Interactive comment on “Do low-cost ceramic water filters improve water security in rural South Africa?” by Jens Lange et al.

Answers to referee #1

Fig. 1. Updated figure 5

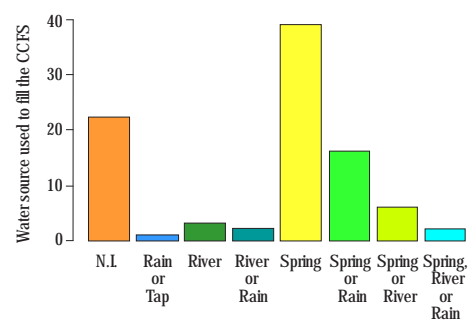
10. Figure 5-please label the y-axis and extend the axis so that even the value for the

'spring only' is easier to read from the axis.

Our answer: Figure 5 will be modified with extended axis. It is attached
